Access Compliance Report

(Curb Ramps)

Intersection ID: 5574	Main Street: BANNER_ELK_DR	Cross Street: SUNSET_RD	Location: SW
ADA ID: 4E7F10391CC7	Ramp Type: Perp	Initial Pass/Fail: Fail	Overall Compliance: No
Codes/Mitigation Info/Possible Solution		Field Measurements/Component Compliance	
Severity Score: 21.25

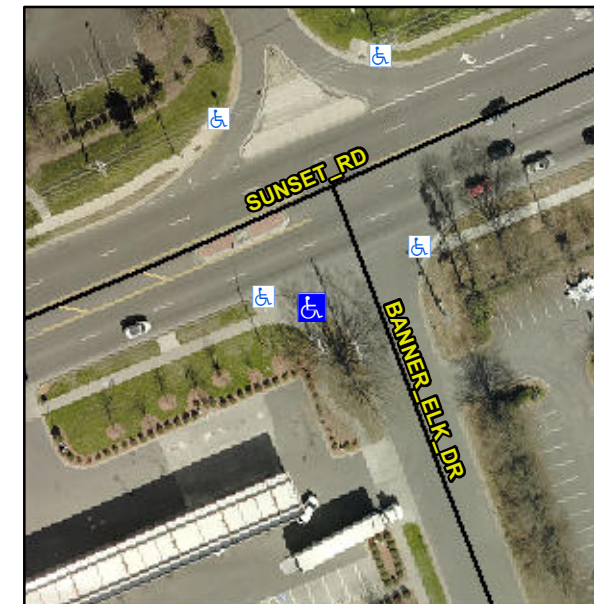
Not Found, R304.5.1, R304.2.2

Compliance	Description	Data	Compliance	Description	Data
N/A	Ramp Length (in)	91.0	No	Ramp Slope (%)	8.4
No	Ramp Width (in)	47.0	Yes	Ramp XSlope (%)	1.9
N/A	Flare Type LT	N/A	N/A	Flare Type RT	N/A
N/A	Flare Slope LT (%)	N/A	N/A	Flare Slope RT (%)	N/A
N/A	Flare Traversable LT?	N/A	N/A	Flare Traversable RT?	N/A
N/A	Landing Length (in)	N/A	N/A	DWS Provided?	N/A
N/A	Landing Width (in)	N/A	N/A	DWS Contrast?	N/A
N/A	Landing Slope (%)	N/A	N/A	DWS Length (in)	N/A
N/A	Landing X Slope (%)	N/A	N/A	DWS Full Width?	N/A
N/A	Landing Curb? (Y/N)	N/A	N/A	DWS Offset (in)	N/A
N/A	Shared Landing?	N/A			
N/A	Gutter Ponding?	N/A	N/A	Gutter Slope (%)	N/A
N/A	Gutter Lip Ht (in)	N/A	N/A	Gutter X Slope (%)	N/A
N/A	Painted X Walk1?	No	N/A	Painted X Walk2?	N/A
	X Walk 1 Direction	To E		X Walk 2 Direction	N/A
N/A	X Walk 1 Width (in)	N/A	N/A	X Walk 2 Width (in)	N/A
	X Walk 1 Slope (%)	1.5		X Walk 2 Slope (%)	N/A
	X Walk 1 X Slope (%)	1.9		X Walk 2 X Slope (%)	N/A

Remove & Replace Entire Ramp.
